SITE SUPPLEMENTAL INSTRUCTION

PROJECT: Forestside Estates
Attmar & Palleschi Drive
Brampton, ON

SITE SI NO. M-1

PURPOSE: To revise mechanical layout to suit architectural CS drawing and City comments for P1 level.

TITLE
**BLOCK 'A'
4TH FLOOR - PLUMBING/SANITARY**

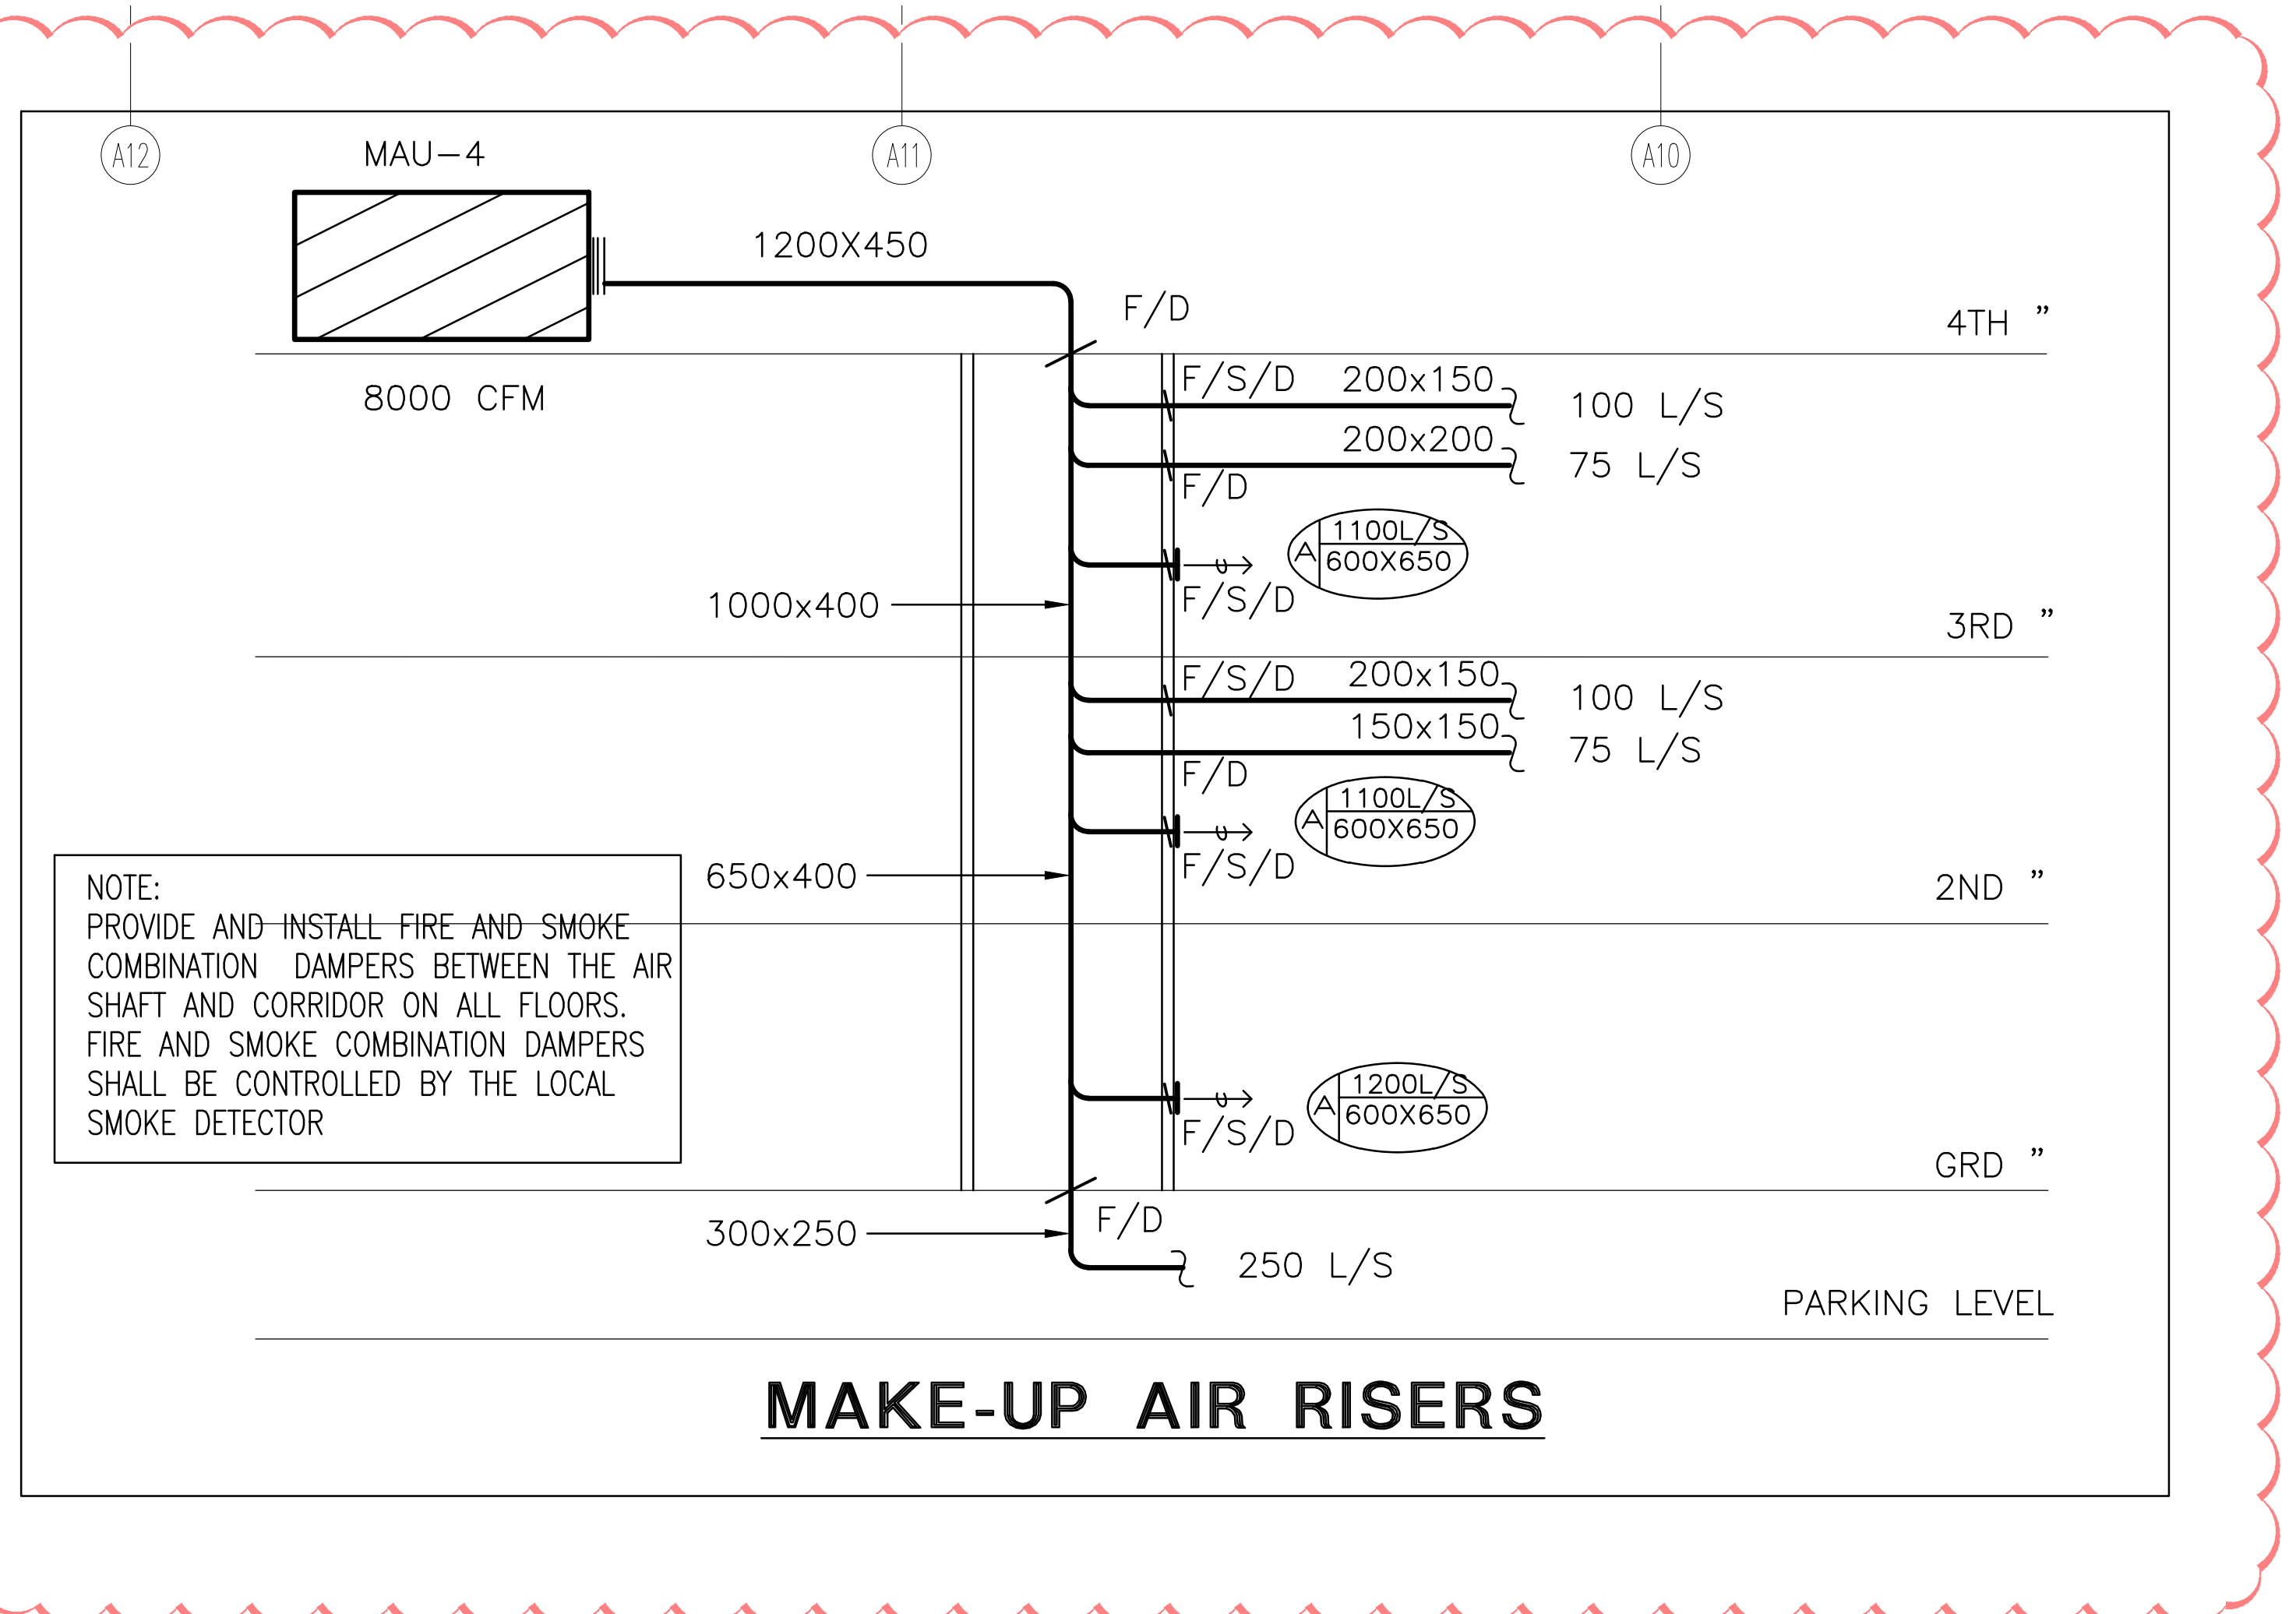
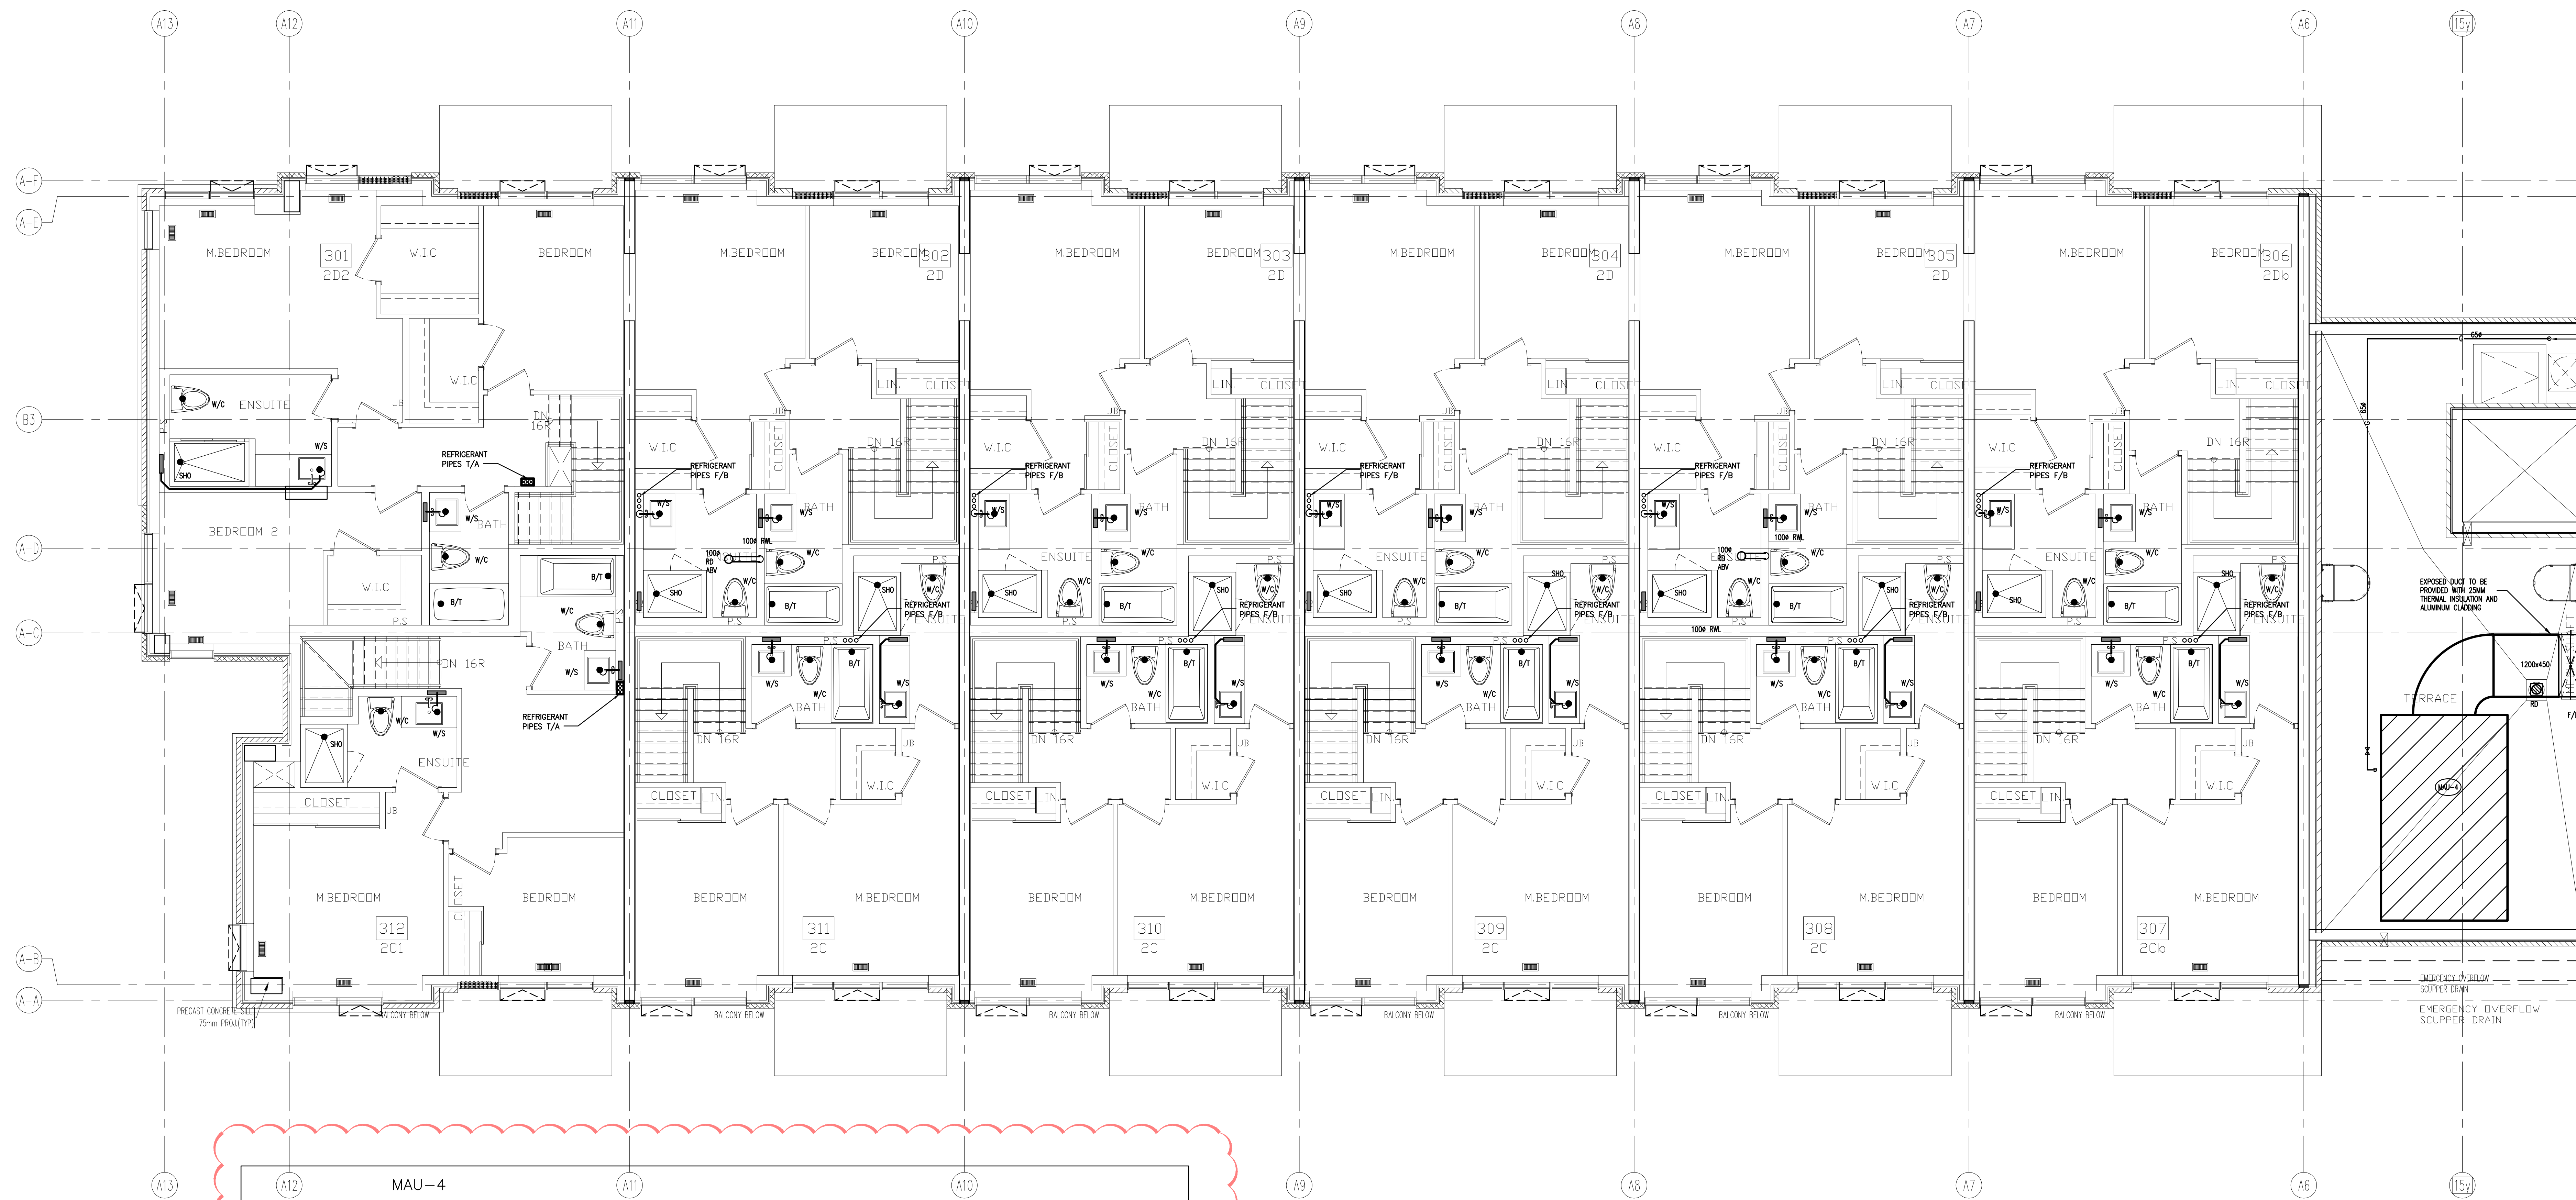
8.0 Reference Drawing M-41 (Blk “A” 4th1 - Mechanical) Issued

8.1 Revise: Mechanical make-up air riser.

8.2 Added: Combined fire and smoke damper for all the opening to public corridor.
